UNITED STATES PATENT AND TRADEMARK OFFICE

10/635,249

Office Action Summary	Application No. 10/635,249	Applicant(s) ROE ET AL.	
	Examiner MICHAEL G. BOGART	Art Unit 3761

DETAILED ACTION

FIG. 2

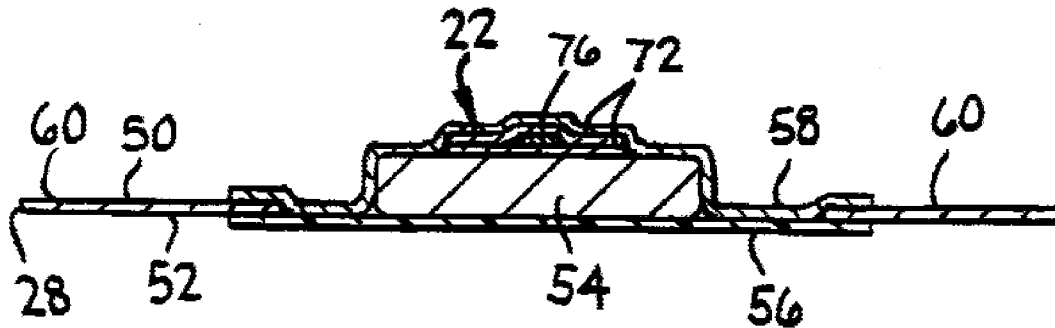
a auxiliary absorbent element (14) disposed on the topsheet (20) along the longitudinal axis, the auxiliary absorbent element (14) includes a permeable layer (44) having a body facing surface, a absorbent substance (42) disposed on the permeable layer (44), and an impermeable layer (28) partially wrapped around the permeable layer (44) such that longitudinal edges (36) of the impermeable layer (28) stop short of meeting, leaving a center portion of the body facing surface of the permeable layer (44) exposed (see figure 2, infra).

Regarding claim 20, Zajackowski teaches an auxiliary absorbent element (42) disposed between the permeable layer (44) and the leg barrier cuff (28, 36)(see figure 2, supra). Brunner teaches that the temperature element may be located under an permeable element (58).

Regarding claim 17, applicants assert that Zajaczkowski discloses that lower surface (28) permeable. This argument is not persuasive because Zajaczkowski teaches that the bottom layer (28, 128) of the secondary absorbent member (14, 114) is impermeable. Liquid will not permeate the material structure that forms the layer itself, it can only travel through cutouts or other areas where there is a void (32, 130) or absence of the layer itself to the primary absorbent assembly. While surface (28, 128) has permeable regions where these cut outs exist, the rest of the surface (28, 128), for example, areas between the cutouts, the layer is impermeable (col. 3, lines 58-68).

reference numbers (28) and (36) refer to a single impermeable sheet of material that forms the leg gathers (34) and elements (28) and (36) can together be reasonably construed as forming leg cuffs. Applicants further assert that absorbent elements (42, 142, 143) are disposed beneath the topsheet (44). This argument is not persuasive because as applied in the detailed rejection of claim 19, reference number (20) is construed as the topsheet, not element (44)(construed as the permeable layer of the secondary absorbent structure (14)). The barriers (28, 34, 36) are disposed on top of the topsheet (20) while the secondary absorbent members (42, 142, 143) are disposed on top of the layer (28, 36) that forms the barriers (34) and below the permeable layer (44) of the secondary absorbent structure (14)(see fig. 2, supra).
